Final SBAD Environmental Impact Reported for the Office San Dieguito Water Storage and Recovery Project San Diego, California

FINAL ENVIRONMENTAL IMPACT REPORT FOR THE SAN DIEGUITO WATER STORAGE AND RECOVERY PROJECT SAN DIEGO, CALIFORNIA

FINAL ENVIRONMENTAL IMPACT REPORT SAN DIEGUITO WATER STORAGE AND RECOVERY PROJECT

Figure 2-5 Site Layout (Phase II)

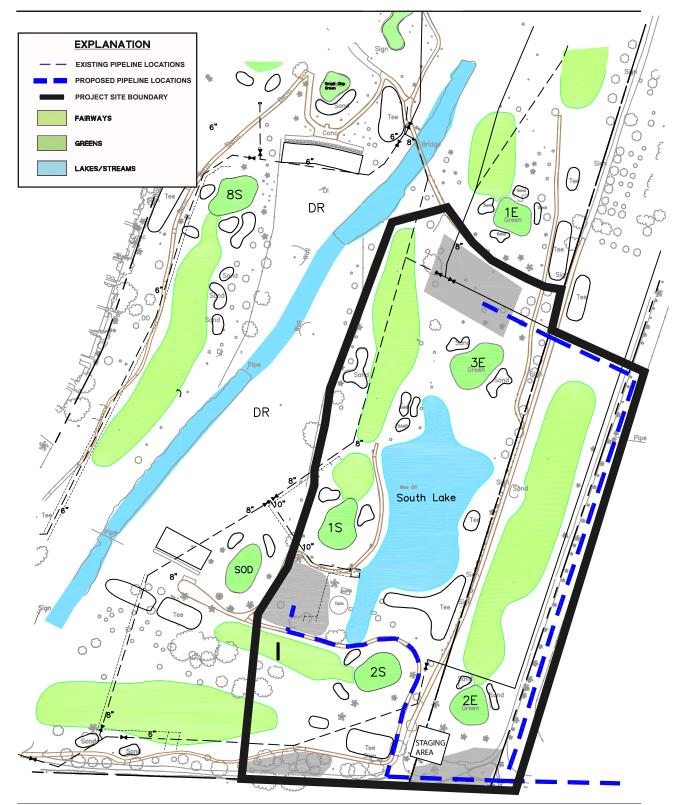
1009 11/18/04 13:51 FAX 760 431 5901 US FISH AND WILDLIFE page 8 Mr. Harry Ehrlich 11. Figure 2-5 depicts the alignment of the proposed pipeline that would connect the source water delivery point and the wellheads. It appears that the pipeline extends outside of the WA-13 development footprint accounted for by the DEIR. Please clarify the entire alignment of the pipeline, any associated loss of sensitive habitats, and appropriate mitigation for those losses. 12. Page 2-13 of the DEIR refers to a 6-inch diameter pipeline and a 10-inch diameter pipeline. WA-14 Please reconcile this apparent discrepancy. 13. The DEIR indicates that the AMP would allow for alternations in injection rates which would minimize the potential for affecting surface water adjacent to the injection/extraction area. Water levels in the river and water quality would be monitored during operation of Phase II, WA-15 and potential effects from the injection/extraction program would be monitored. The final EIR should reflect that OMWD would take action as needed based on the monitoring, not merely that the AMP "would allow" actions to be taken. The Department finds that the proposed Project would not be de minimis in its effects on fish and wildlife per section 711.4 of the California Fish and Game Code. Please contact Libby Lucas of the Department at (858) 467-4230, or Ben Frater of the Service at (760) 431-9440, if you have any questions or comments concerning this letter. Sincerely, 4 Martin Donald Chadwick Therese O'Rourke Habitat Conservation Planning Supervisor Assistant Field Supervisor South Coast Region Carlsbad Fish and Wildlife Office California Department of Fish and Game U.S. Fish and Wildlife Service Orange County Water District (Richard Zembal) cc by fax only: San Diego Regional Water Quality Control Board (Michael Porter) U.S. Geological Survey (Eric Reichard) White Environmental Consulting (Jack White) 760 431 5901 Page 9 NOV 18,2004 13:59

- WA-13 In Figure 2-5, the dashed line extending to the east (and seemingly outside the designated project site boundary) is, in fact, the alignment of the existing 10-inch supply pipeline that connects Morgan Run to the District's 153 Extension Pipeline (in San Dieguito Road). This line was erroneously depicted as a "Proposed Pipeline Location." A correcting change to Figure 2-5 has been included in the Final EIR.
